DEVELOPMENT APPLICATION ASSESSMENT REPORT

Application Number:	DA2020/1597
----------------------------	-------------

Responsible Officer:	Anne-Marie Young
Land to be developed (Address):	Lot 25 DP 7002, 67 Pacific Parade DEE WHY NSW 2099
Proposed Development:	Demolition works and construction of a boarding house development
Zoning:	Warringah LEP2011 - Land zoned R3 Medium Density Residential
Development Permissible:	Yes
Existing Use Rights:	No
Consent Authority:	Northern Beaches Council
Delegation Level:	NBLPP
Land and Environment Court Action:	Yes
Owner:	BL2093 Pty Ltd
Applicant:	Benson McCormack Architects Pty Ltd

Section BB showing the side envelope breach (source Benson McCormack)

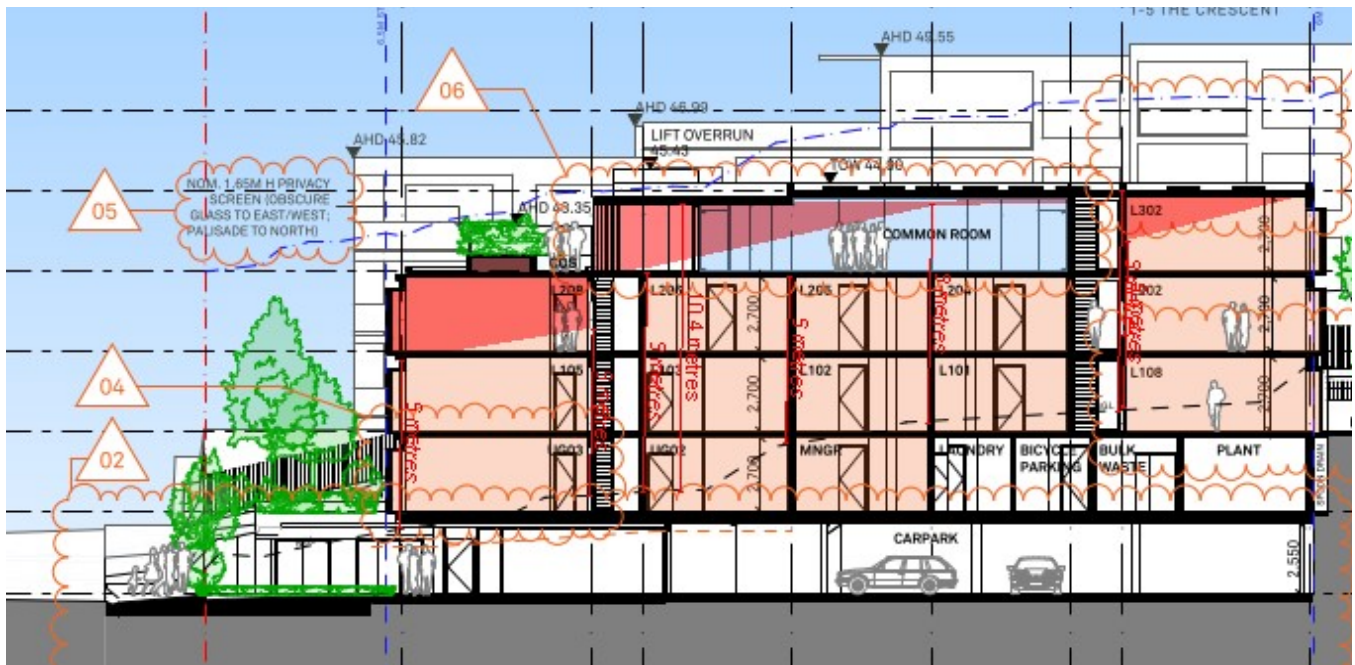
Area 1 - (3m - 2.4m in height x 7.6m in length) which relates to unit L208 and the roof top planter.

Area 2 - (2.9m - 0m in height x 12m in length) which relates to the roof top common room.

Area 3 - (1.9m - 0m in height x 5.7m in length) which relates to unit L302

Section AA showing the side envelope breach (source Benson McCormack)

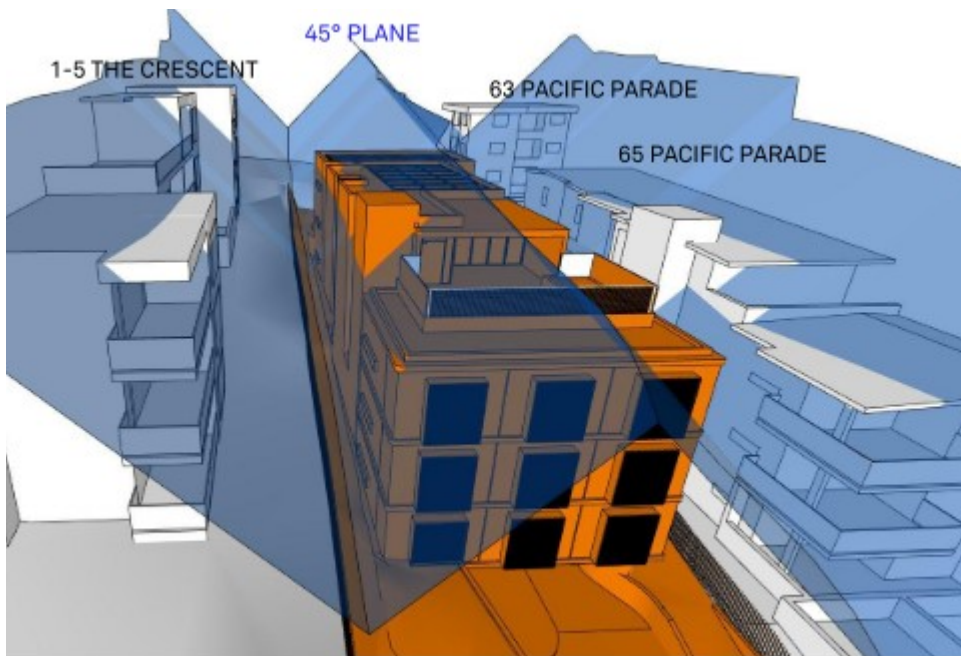
Area 1 - (3.9m - 0m in height x 23m in length) which relates to the lift shaft, the top of the central service core and the top of unit L301

Area 2 - (1m - 0m in height - 6m in length) which relates to the top of unit L209

3D image of 45 degree plane showing envelope breach (source B McCormack)

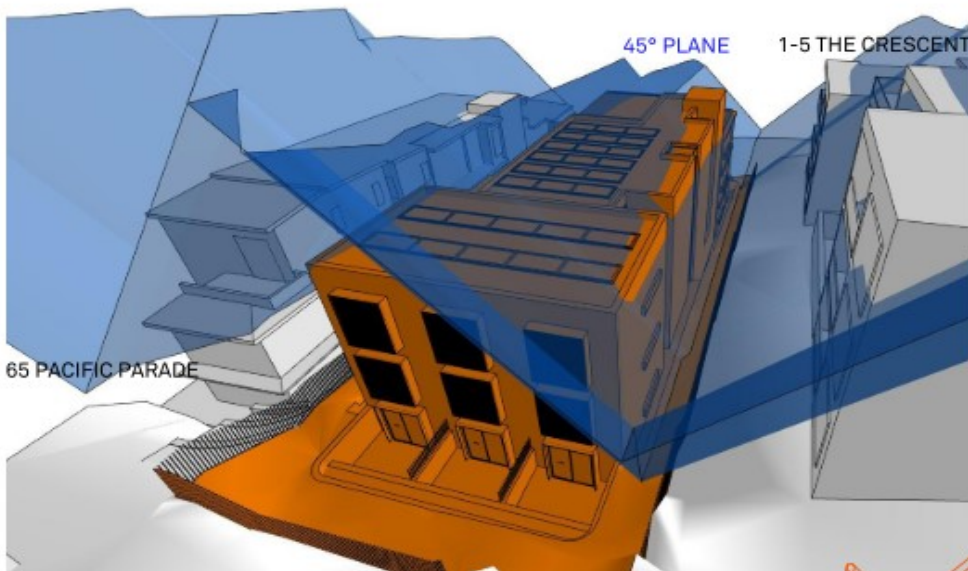
There is no increased in the side setbacks as the wall height increases and the proposal results in large areas of continuous wall planes with little visual relief or articulation especially along the eastern elevation. The bulk and scale of the development is excessive and the building presents as a three storey development to the street with minimal articulation or reference to the light weight treatment of the surrounding residential flat buildings.
